MAINE TURNPIKE AUTHORITY

ADDENDUM NO. 3

CONTRACT 2018.13

GUIDE SIGN MODIFICATIONS, PHASE III  
MAINE TURNPIKE EXITS 32, 36, 42, 44, AND 45  
**MILE 16.9 TO 63.0**

SHEET NUMBER: 2

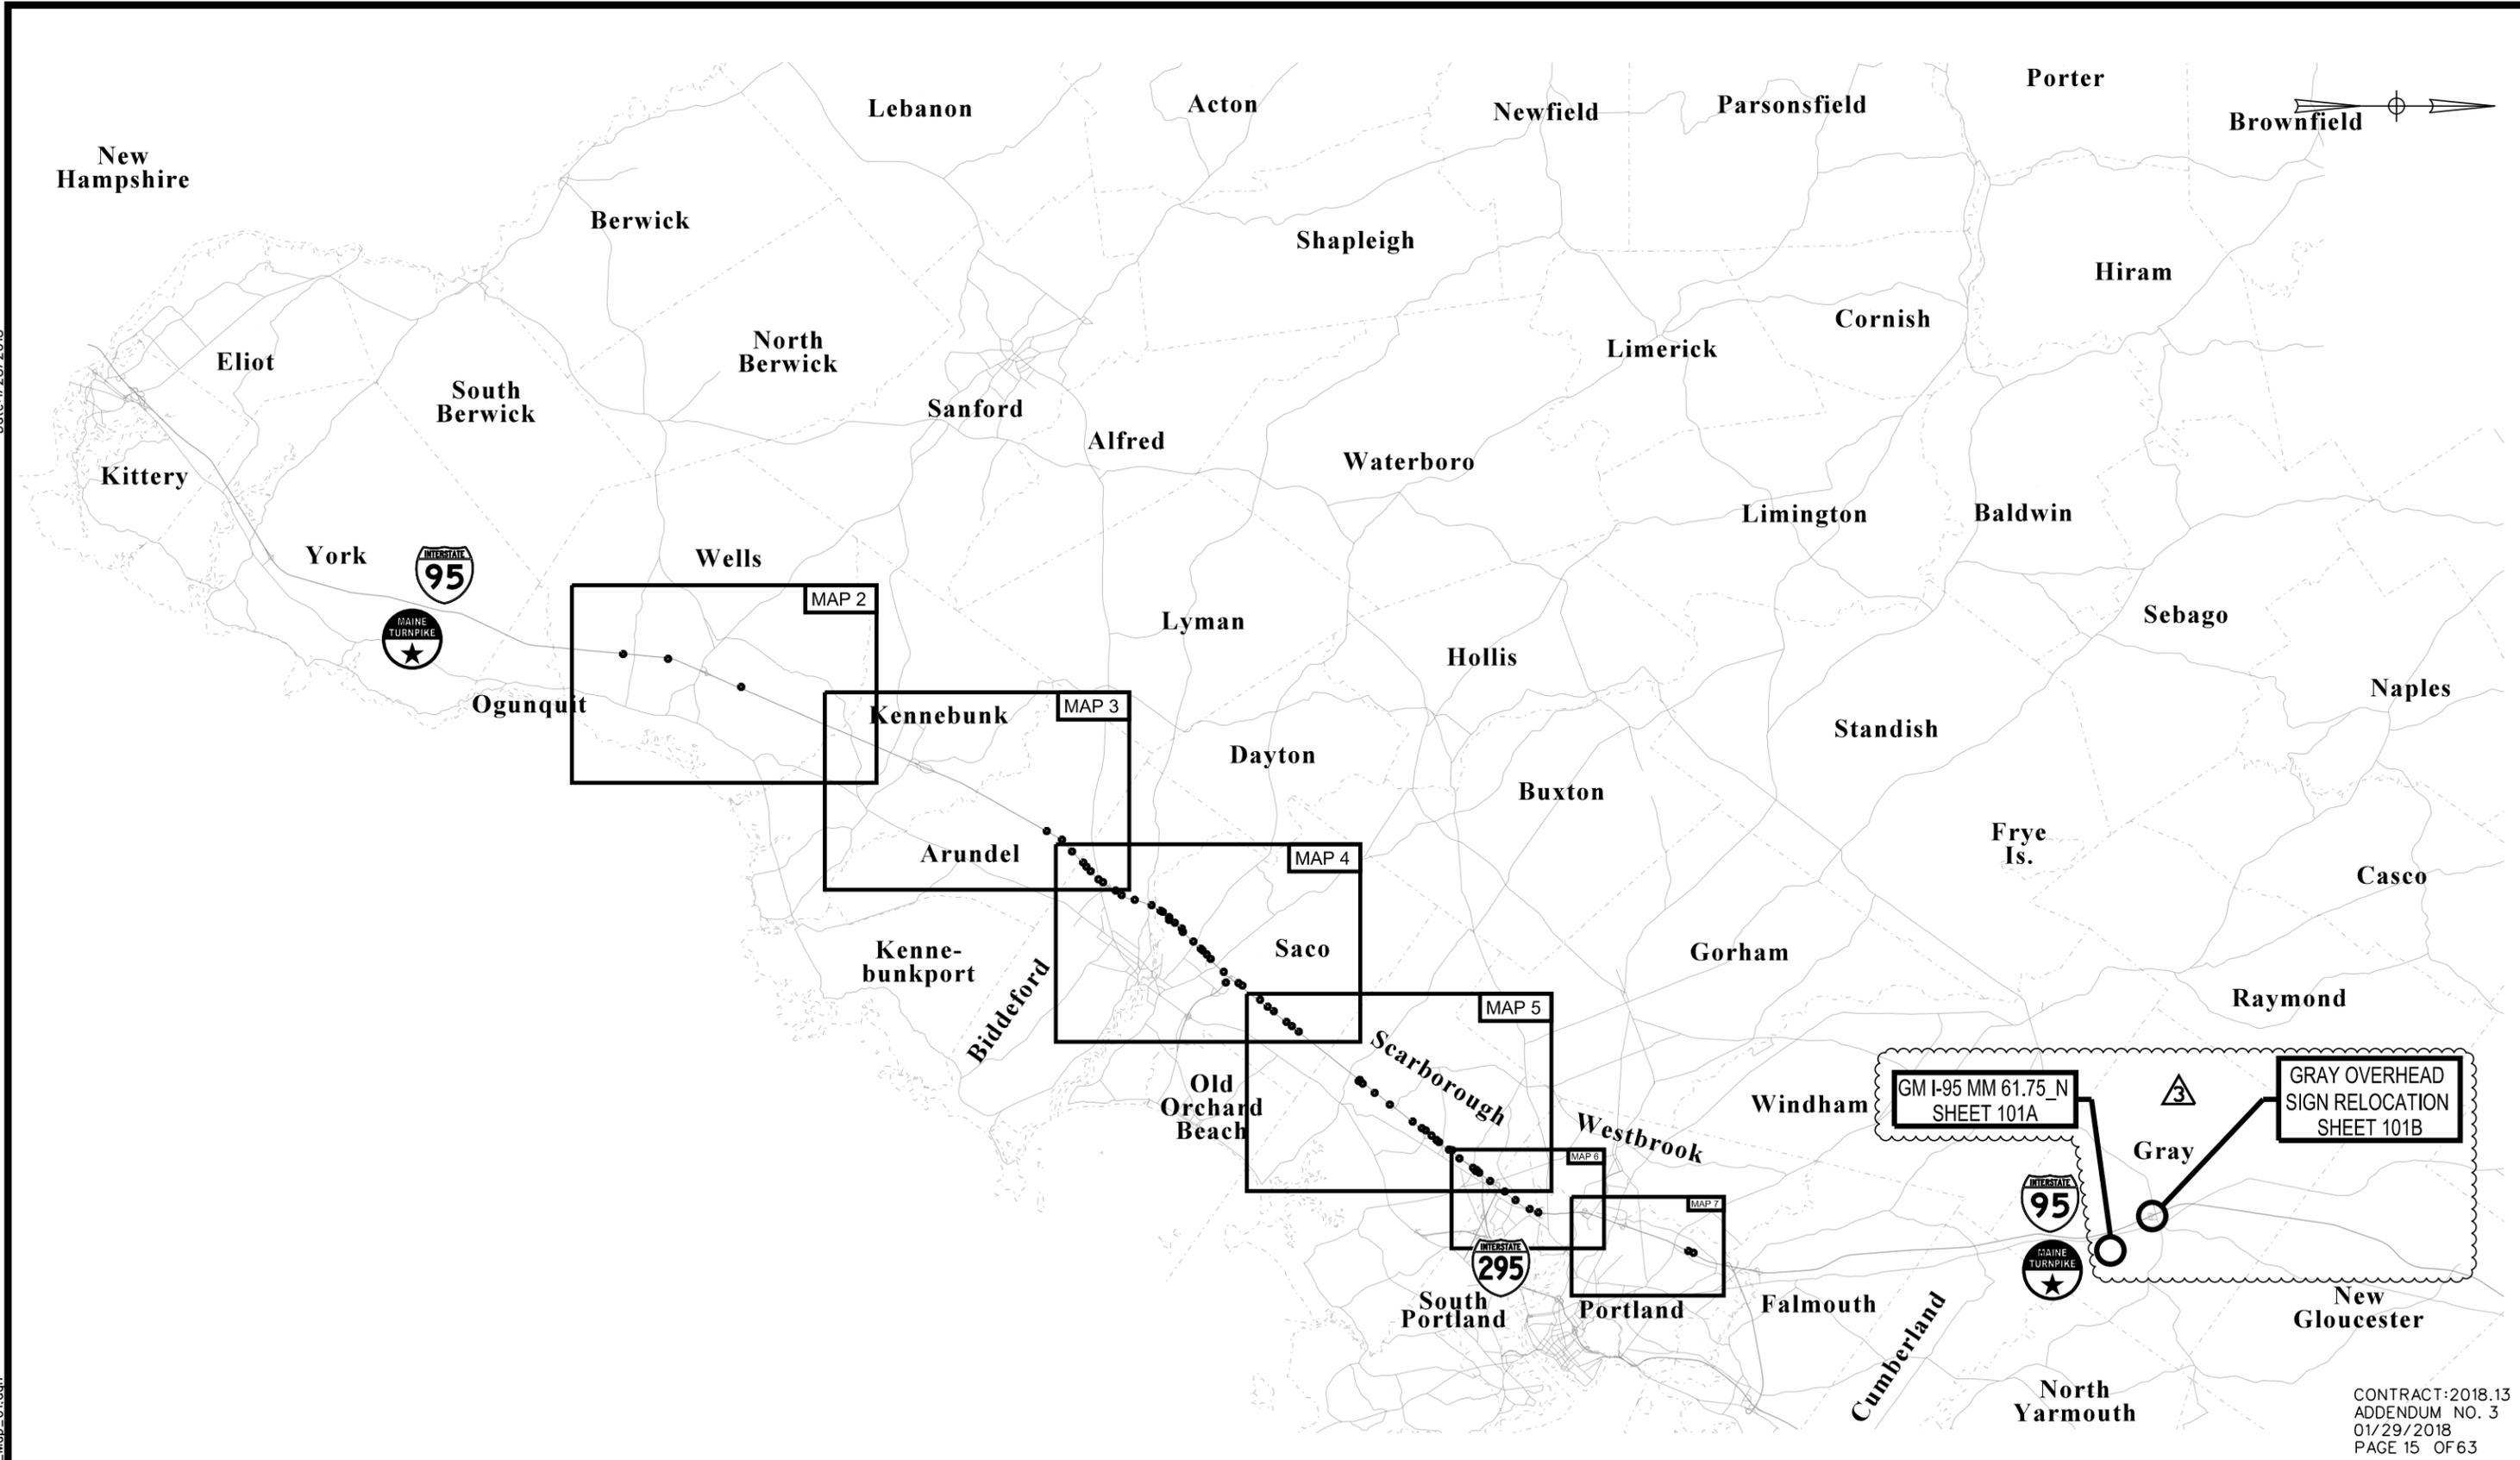
In the Contract Plans, **REMOVE** Sheet 2 and **REPLACE** with the attached Sheet 2 that modifies Savaging Signs and Sign Supports Note 2 and adds Traffic Control Note 9.

*Response: Yes; a note has been added to Sheet 2 General Notes, as Traffic Control #9 to require a lighting plan for night work. See also the Supplemental Specifications for 652*

SHEET NUMBER: 3  
CONTRACT: 2018.13  
ADDENDUM NO. 3  
01/29/2018  
PAGE 15 OF 63

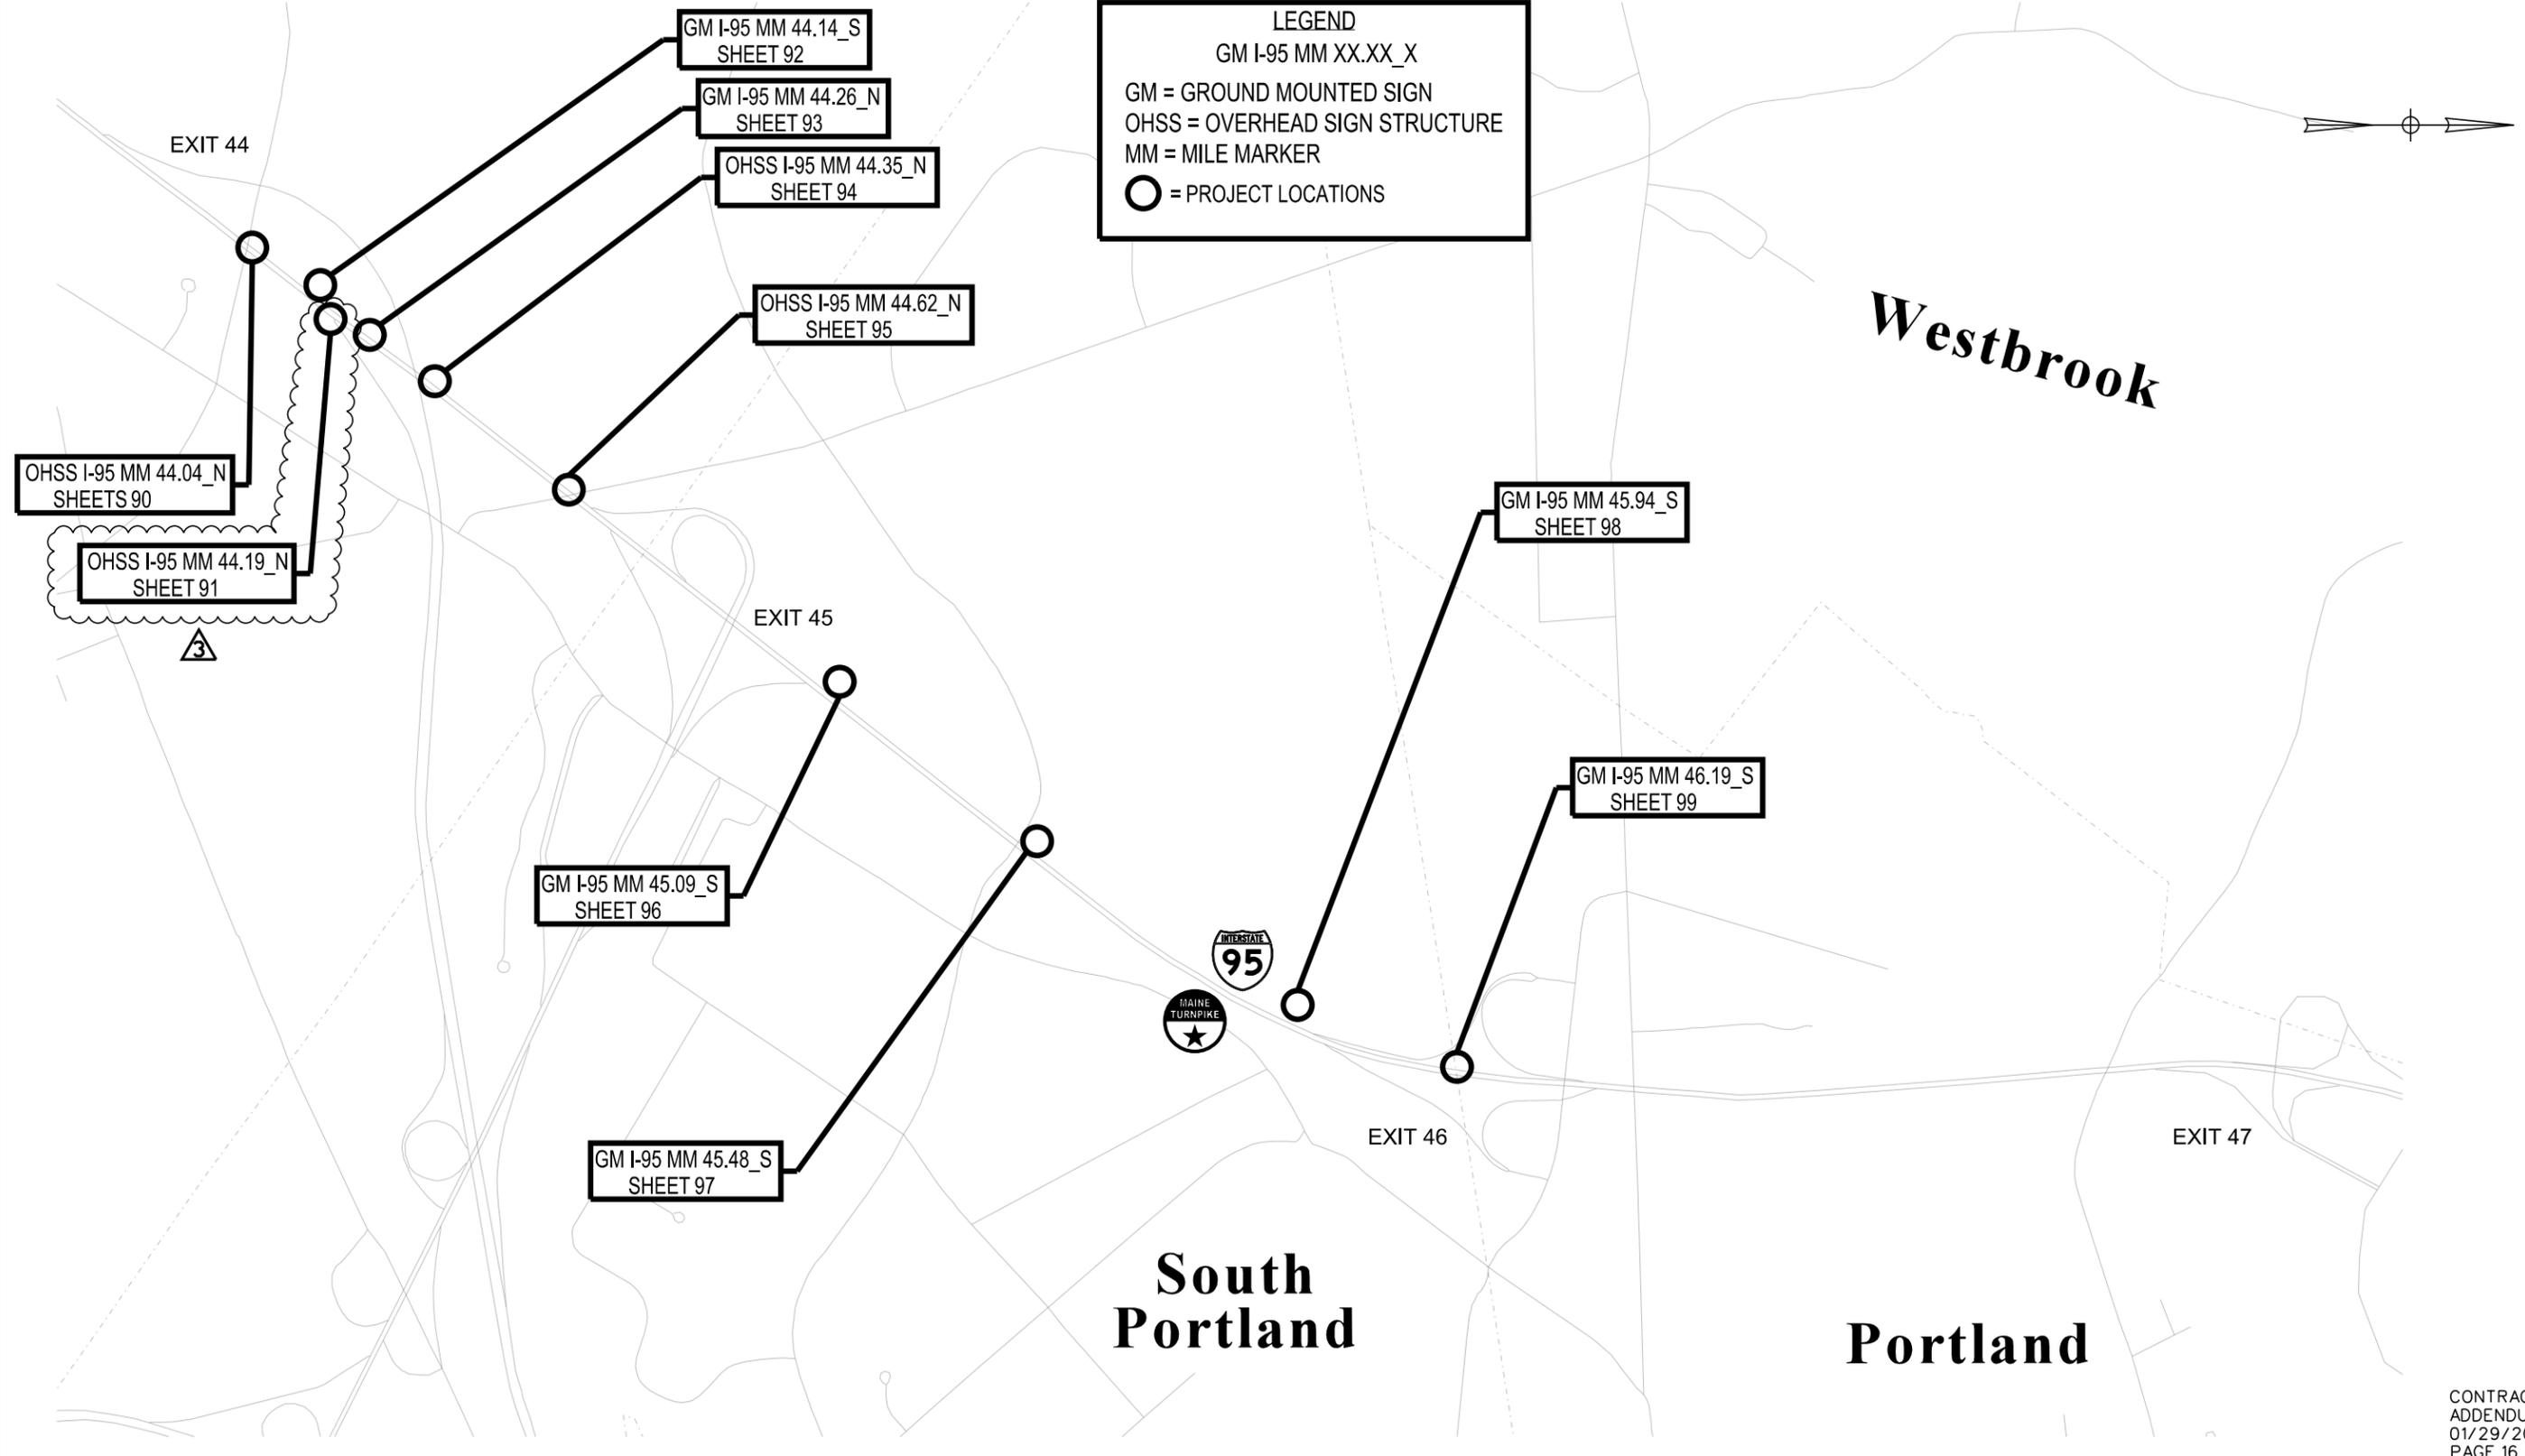
In the Contract Plans, **REMOVE** Sheet 3 and **REPLACE** with the attached Sheet 3 that adds sheet references for the new sheets 101A and 101B.

SHEET NUMBER: 8

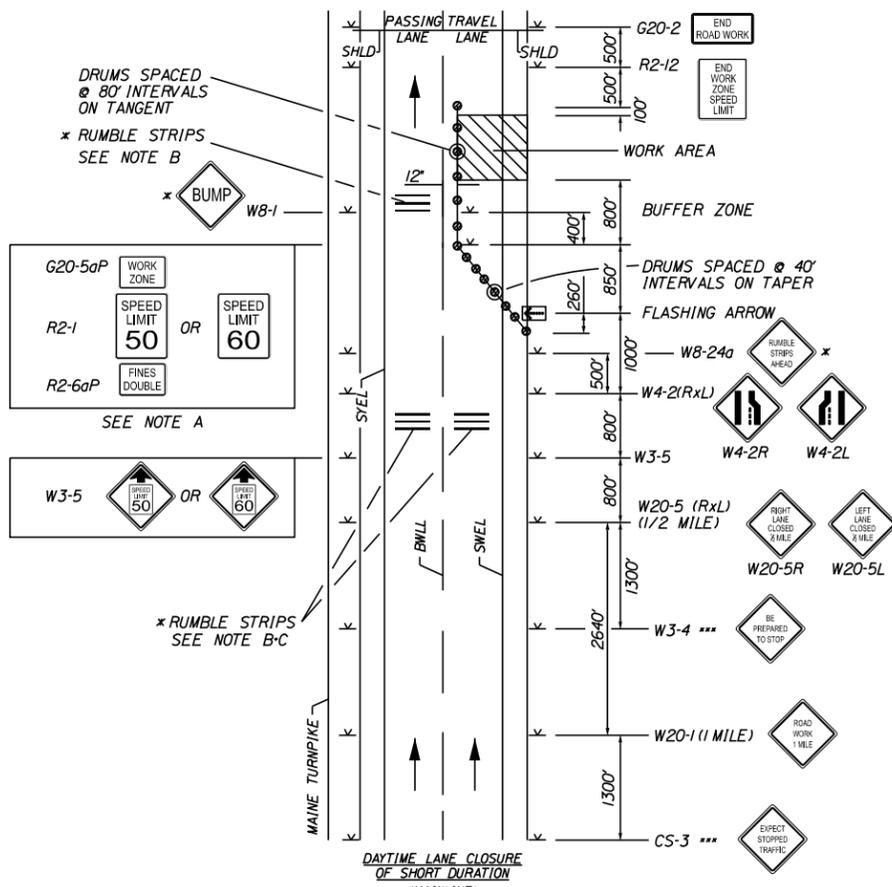
In the Contract Plan, **REMOVE** Sheet 8 and **REPLACE** with the attached Sheet 8 that moves the overhead sign structure and sign from MM 44.14\_N to MM 44.19\_N.

SHEET NUMBER: 20  
20 OF 101

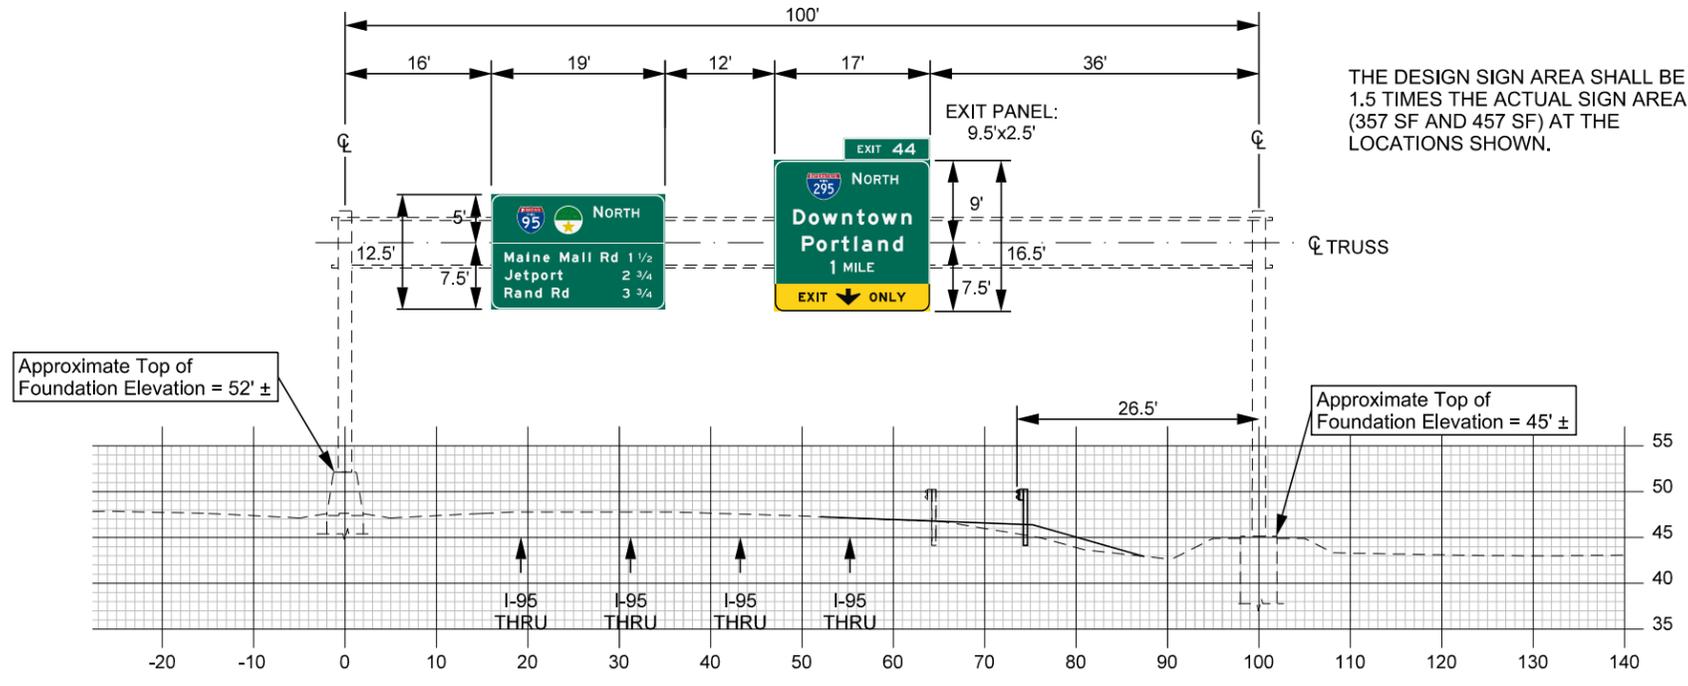
In the Contract Plans, **REMOVE** Sheet 20 and **REPLACE** with the attached Sheet 20 that modifies the quantity of Exit 44 signs and re-names one location for an Exit 45 sign.
